Telephone #_ 723-9227 27M- 47 Plan #_ Project name: WHITE TAIL RIDGE Civic Address: 172 FRANK FISHER CRESCENT House model: NEWINGTON R

SITE/GRADING PLAN WHITE TAIL RIDGE PH.II

Re: Proposed Single Family Dwelling, 172 Frank Fisher Crescent, Lot # 117 White Tail Ridge, Arnprior, Kollaard Associates File # 230020

With regard to structural issues only, Kollaard Associates has reviewed the following drawings:

09/08/23 CB 518 footprint: CB drawn by: date: JUN 12/16 3/16"=1'-0' scale: D.C.L. - A5 1R of sheet no:

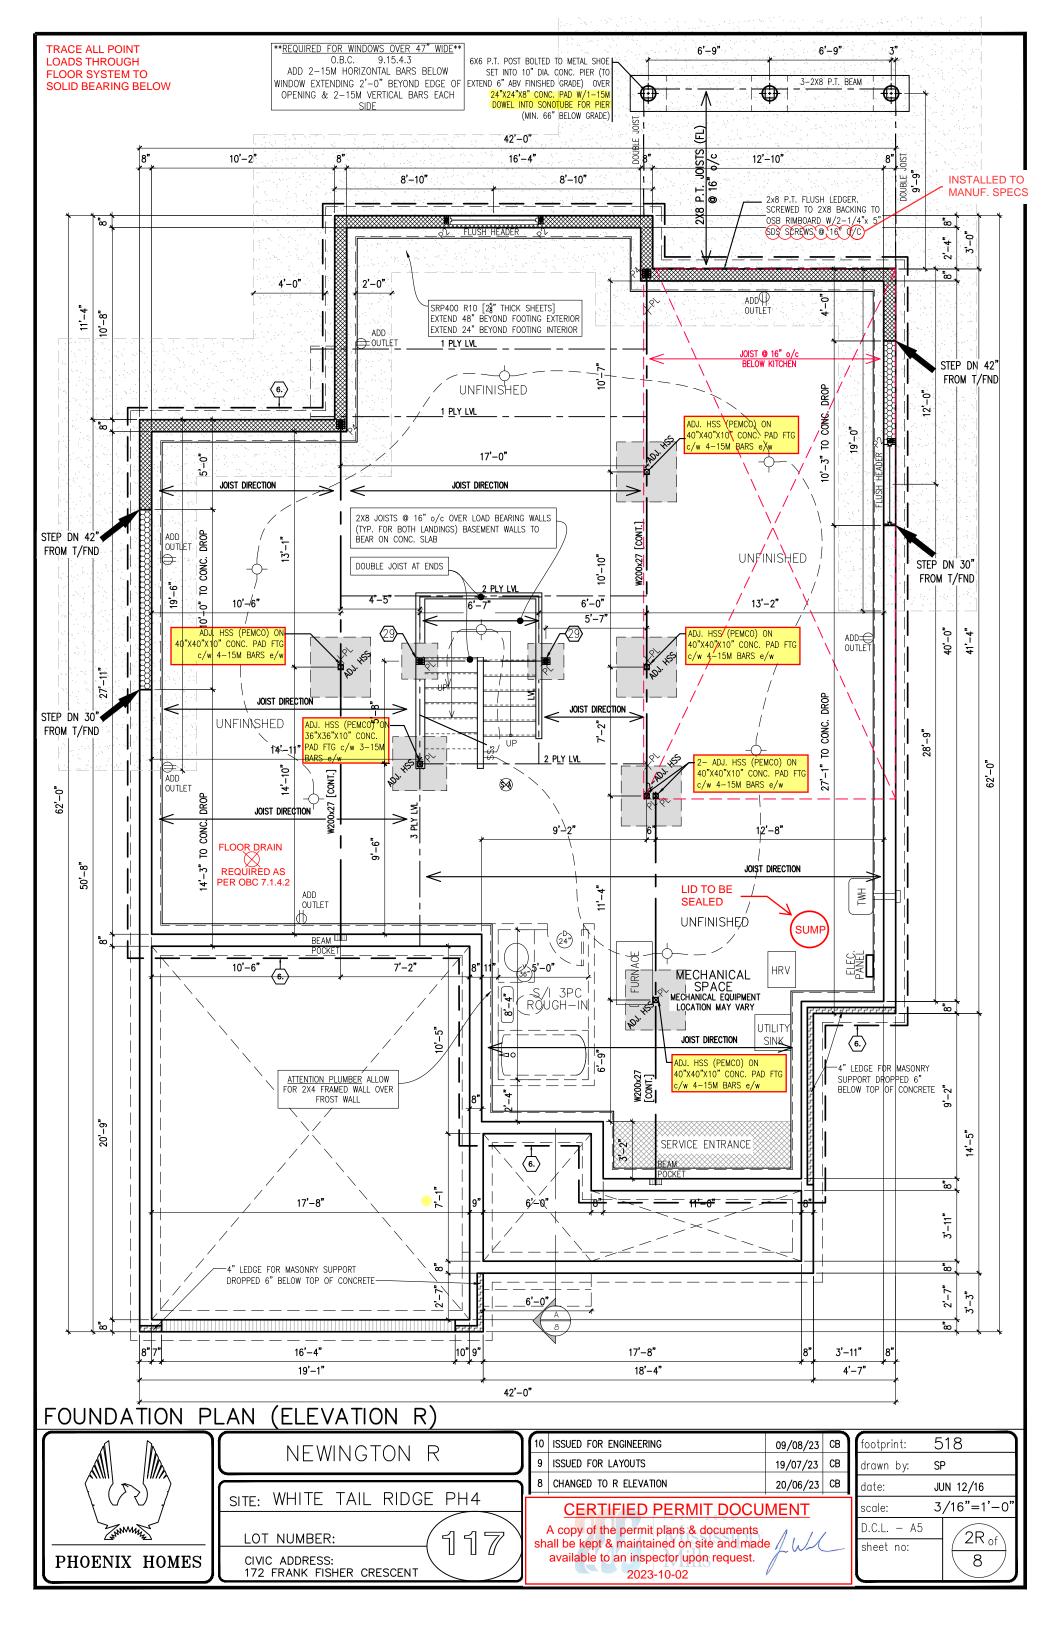
- 12. The front porch slab reinforcement described on Phoenix Homes Sheet # 1R is adequate.
- 13. As noted on Phoenix Homes Sheet # 2R, the framed walls supporting the intermediate landing may be supported by the basement slab.

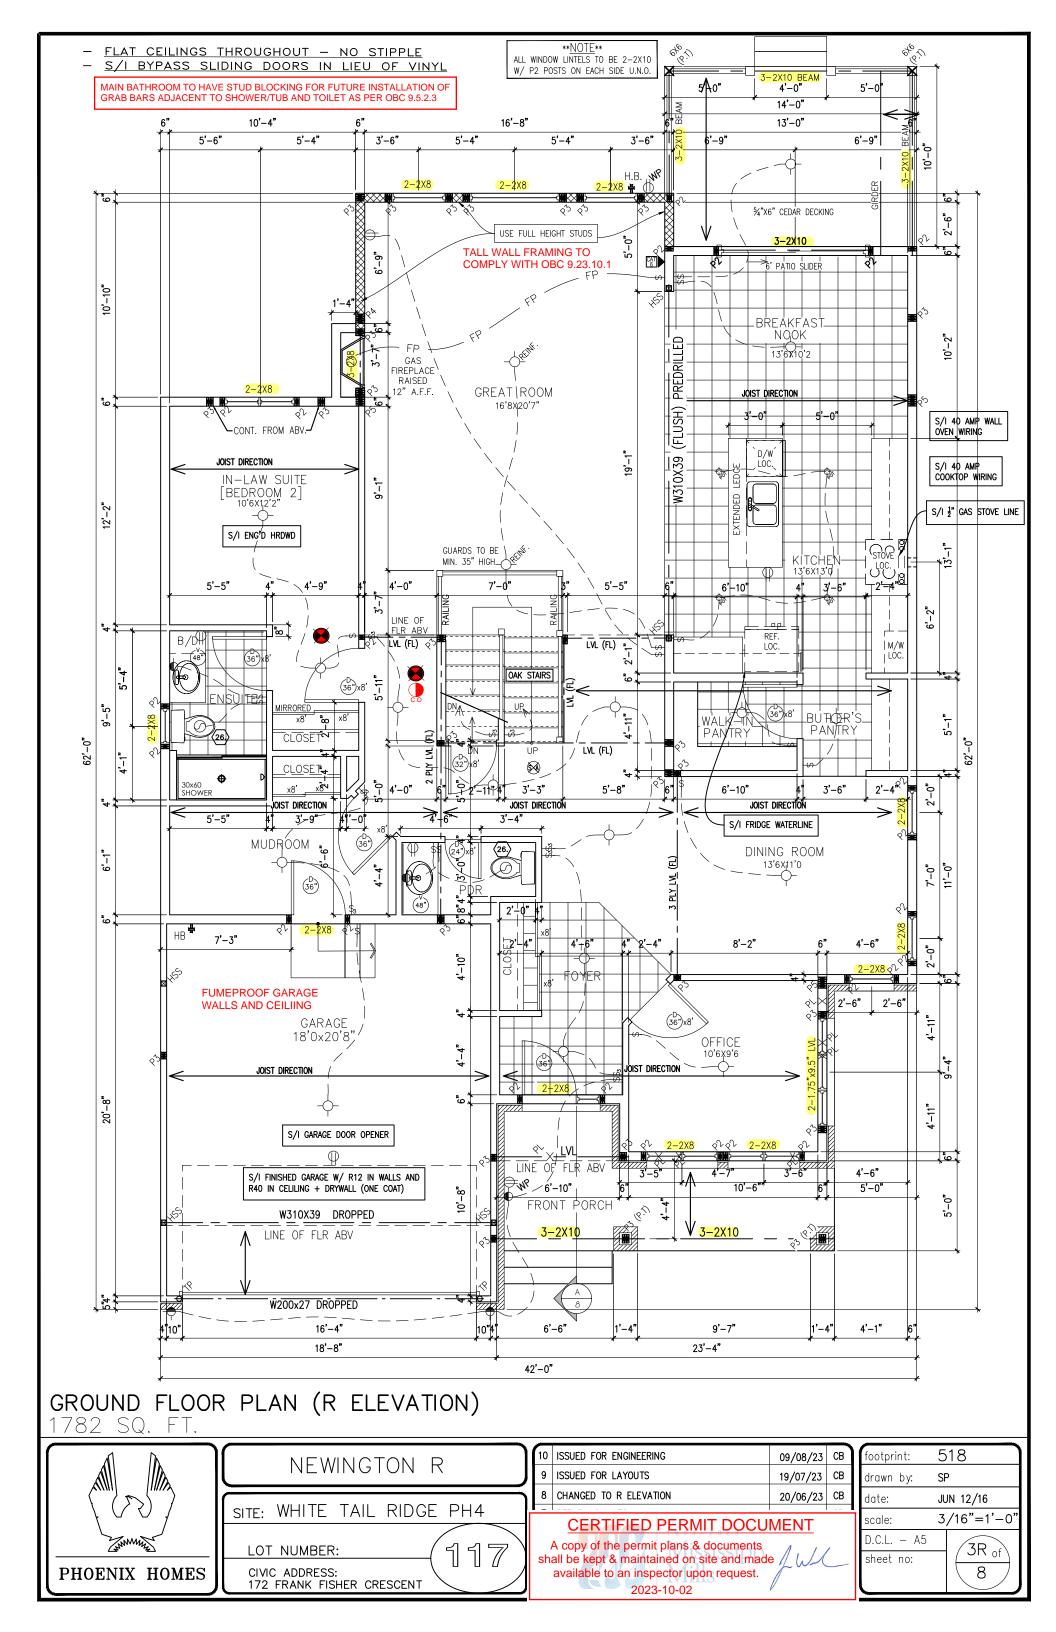
- 10. It is the opinion of Kollaard Associates that the proposed steel beams steel posts shown on Phoenix Homes Sheet # 2R are adequate.
- 11. It is the opinion of Kollaard Associates that the proposed deck beams, posts, joists, sonotubes and ledger connection shown on Phoenix Homes Sheet # 2R and are adequate.

- 16. The proposed strip footings, interior pad footings and exterior pad footings shown on Phoenix Homes Page # 2R and noted on Phoenix Homes Sheet # 1 are adequate.

- 17. Floor joist design, flush LVL beams within the floor structure and LVL lintels are by the manufacturer. The posts supporting the flush LVL lintels shown on Phoenix Homes Sheet # 2R are adequate.

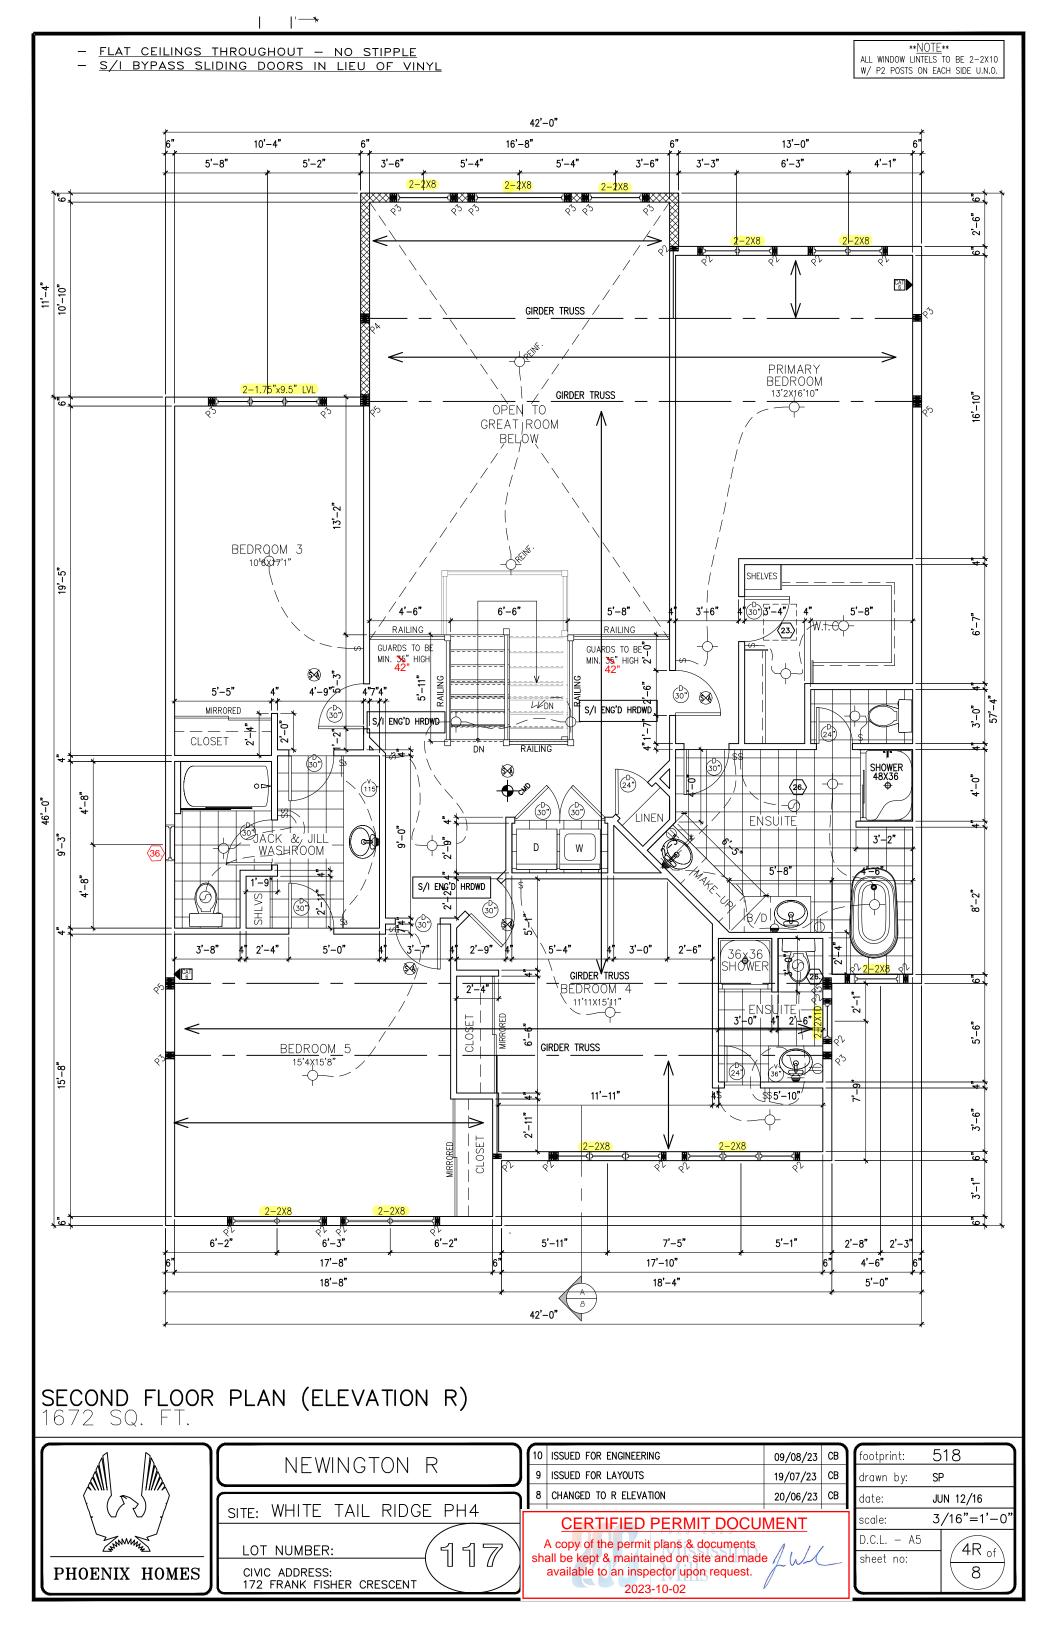
5. It is the opinion of Kollaard Associates that the proposed lintels, beams and supporting posts shown on Phoenix Homes Pages # 3R are adequate

- Ramset a 2x6 to the top flange of all steel beams to attach the above framing, floor joists and flush LVL beams.
- 7. The proposed web packing of the steel beam detailed on Phoenix Homes Sheet # 8R is adequate.
- 8. Truss design is by others.
- 9. Floor joist design and flush LVL beams within the floor structure are by the manufacturer.
